Coffs Harbour Bypass

Submissions Report

Volume 1. Executive summary, Chapters 1-3

Figure 3.1-1 Englands Road Interchange strategy for pedestrians and cyclists

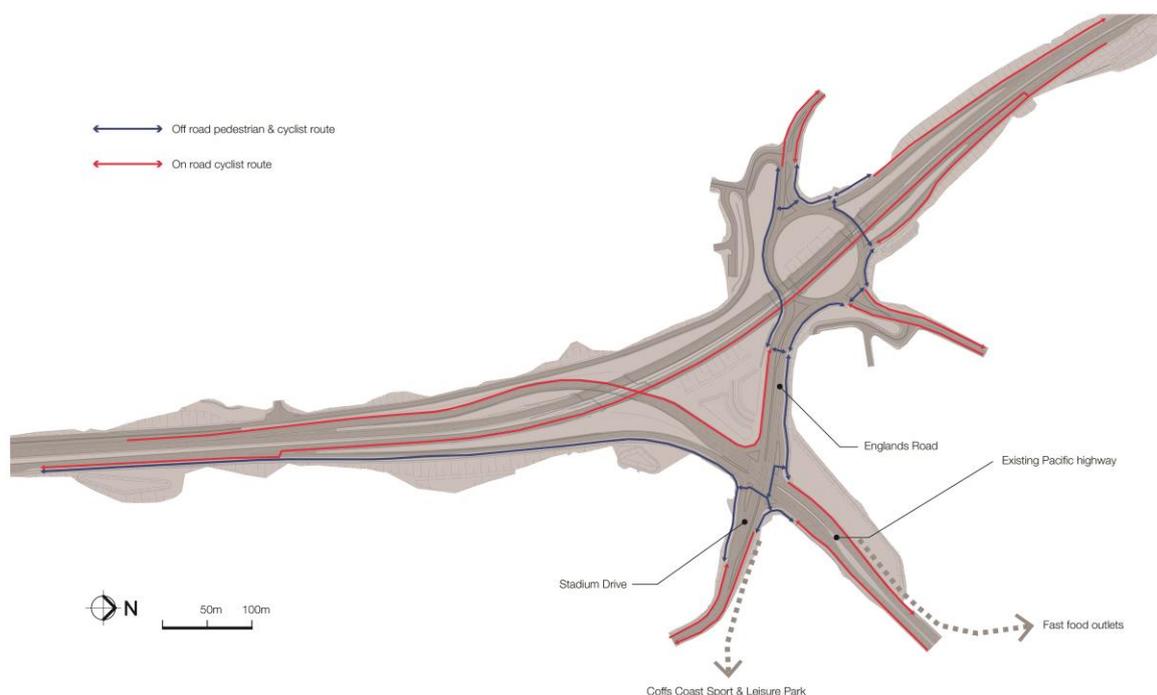
The plans provided by TfNSW in Chapter 5, Project description of the EIS (Figure 5-21-02) identified the 'proposed footpath' at Englands Road interchange incorrectly. However, as identified throughout Chapter 5, Project description of the EIS and by CHCC, this is an existing shared user path. This shared user path would be reinstated to its existing condition on the eastern side of the project. This means the path can be used by both pedestrians and cyclists. The plans have since been updated with the correct terminology (refer to Figure 2-1 of Chapter 2, Design changes of the Amendment Report).

In addition, signalised pedestrian crossings would be provided at the signalised intersection with the existing Pacific Highway, Englands Road and Stadium Drive. As shown in **Figure 3.1-1**, these crossings would enable pedestrians and cyclists to safely cross the intersection.

Figure 3.1-6 Coachmans Close cross section (section AA)

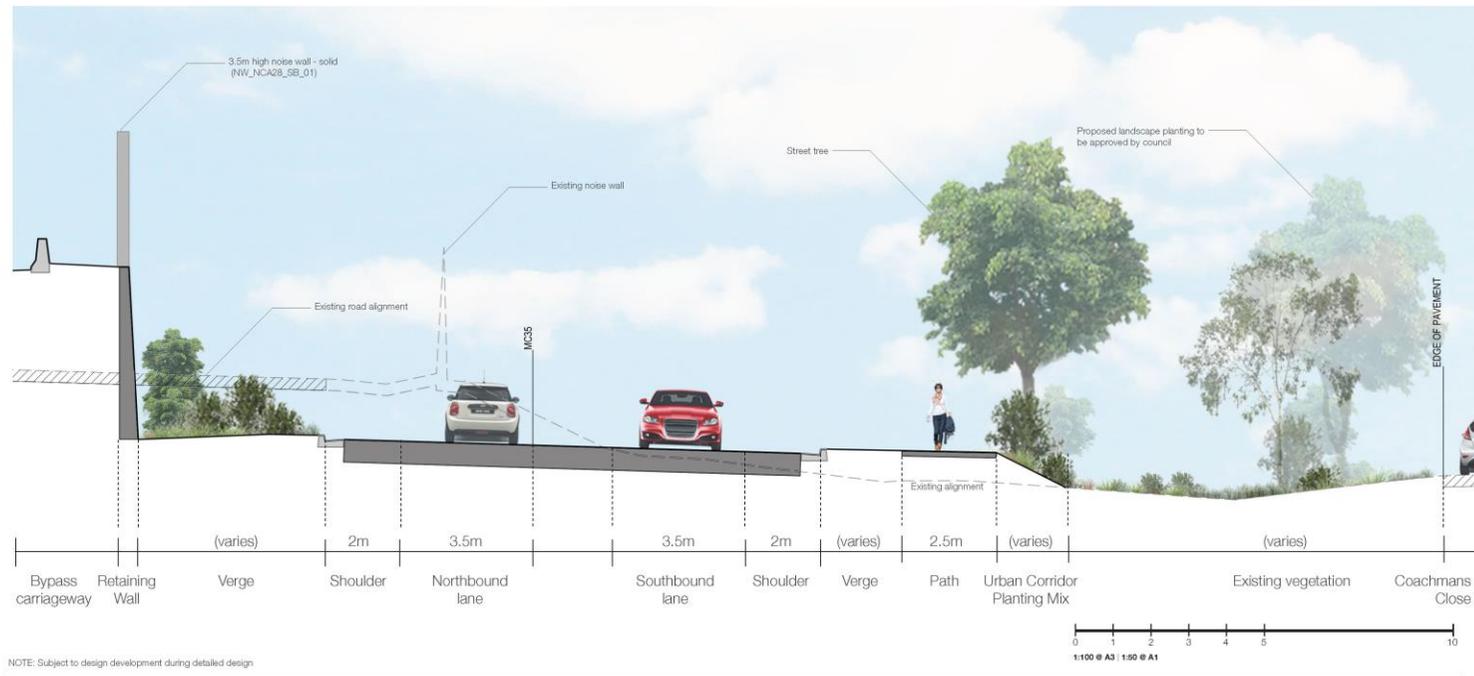
- Before and after artist's impression from two locations along Coachmans Close. The first is from the top of Coachmans Close looking towards the south (refer to **Figure 3.1-2** for the existing view and **Figure 3.1-3** for the view with the project). The second from near Fernleigh Avenue, looking towards the south (refer to **Figure 3.1-4** for the existing view and **Figure 3.1-5** for the view with the project)
- Cross-sections at two locations along Coachmans Close showing the relationship between Coachmans Close and the service road, including the width available for vegetation screening between the two roads (refer to **Figure 3.1-6** and **Figure 3.1-7**). These cross-sections highlight the varying width available for between the two roads, which range from about 10 metres at its widest and about 1.5 metres at its narrowest.

TfNSW acknowledges the vegetation within this area is of importance to the community and provides screening value. As illustrated in **Figure 3.1-33**, Coachmans Close north of Fernleigh Avenue, vegetation would be retained where possible to assist with screening views towards the project. During detailed design, an arborist assessment will be carried out to confirm the extent of vegetation that could be retained along Coachmans Close within the construction footprint (refer to

As the road descends to the south and the space narrows, it is anticipated that shrub planting would be provided to screen lower level views from the adjacent properties, as illustrated in **Figure 3.1-55**. As identified in environmental management measure UD01, an Urban Design Landscape Plan will be prepared to support the detailed design of the project. The plan will include identification of existing vegetation and proposed landscape areas, including areas along Coachmans Close. As part of this plan TfNSW will explore the opportunities to provide shrub planting in the form of a maintained hedge to allow the screening value to improve over time.

Figure 3.1-8 SEIA study area and Boambee East -Toormina area

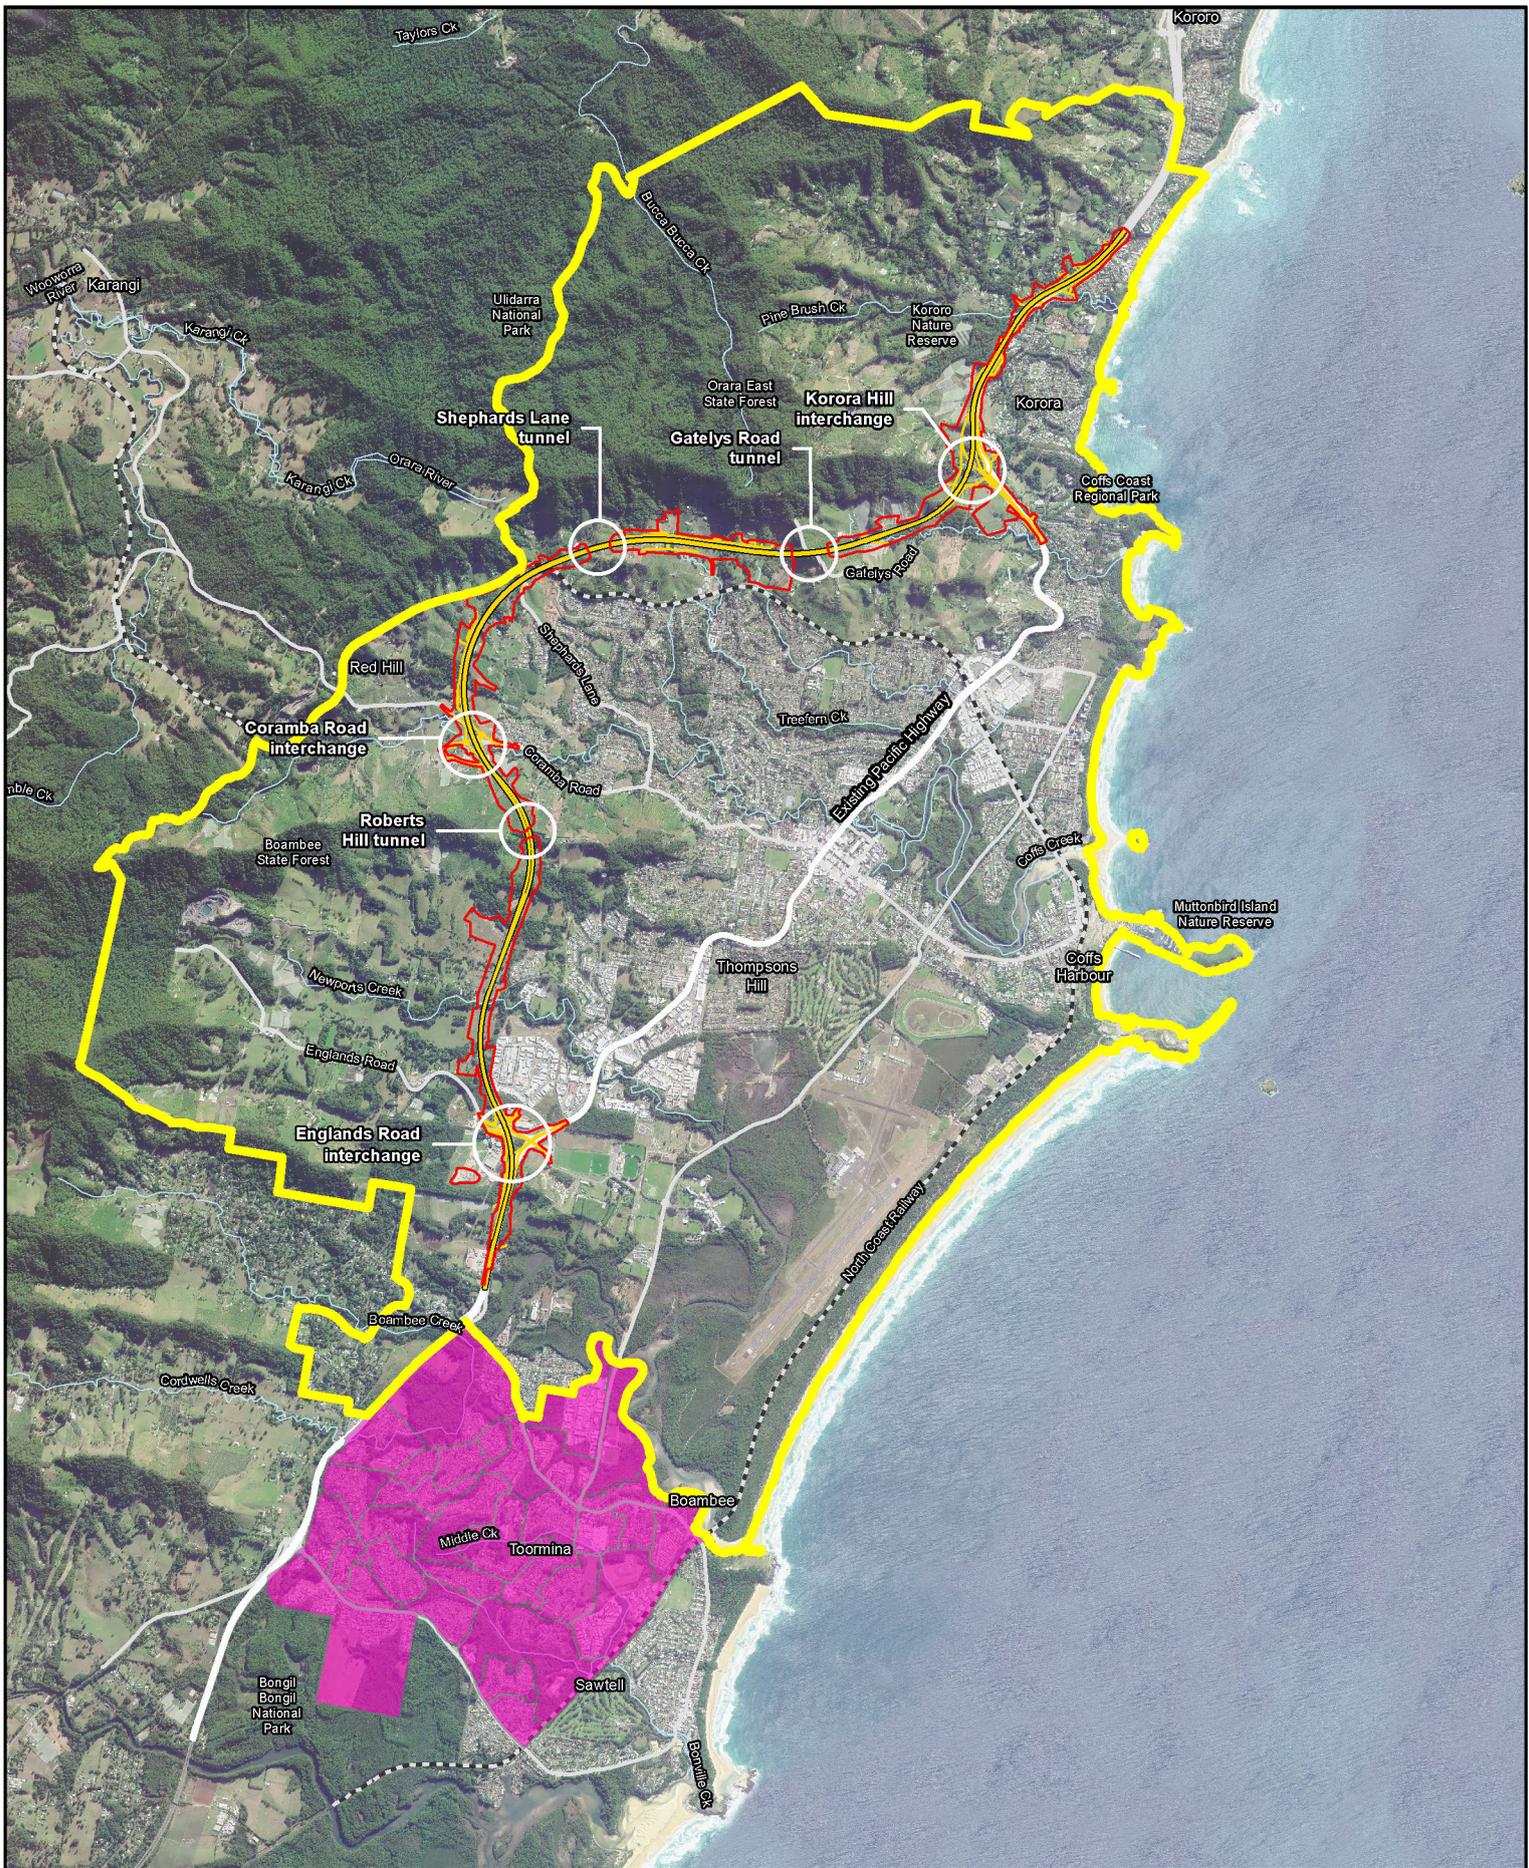
- The socio-economic impact assessment (SEIA) study area does not include residential areas and communities such as Boambee East, Toormina and the Northern Beaches. This is of particular relevance when understanding the potential impact on affordable housing and service provision across the Coffs Harbour LGA. Figure 14-4 of the EIS indicates areas near to the SEIA study area boundary that are in the lower decile of disadvantage. Potential impacts on these areas from the project should be considered. It is acknowledged that some data and associated analysis is compared at the local government level and State level, but key service and community areas appear to have been excluded from the broader analysis and impact assessment

However, to address CHCC's concerns regarding the potential social and economic impacts of the project in this area, additional assessment has been carried out for the Boambee East-Toormina area (shown in **Figure 3.1-8**). The Northern Beaches (Sapphire Beach and Moonee Beach) are more than 1.5 kilometres and six kilometres north of the project respectively, and these communities are unlikely to be impacted by the project. It is noted that the project would improve access and connectivity between the northern beaches and the SEIA study area, which contain social services and facilities which serve these communities.

The Boambee East-Toormina residential communities (as shown in **Figure 3.1-8**) span across 32 SA1s. The 2016 census recorded 11,397 people living in the Boambee East-Toormina area, split fairly evenly between males (48 per cent) and females (52 per cent). The median age of the population in the Boambee East-Toormina area was 42 years old, similar to the EIS SEIA study area of 43 years old.
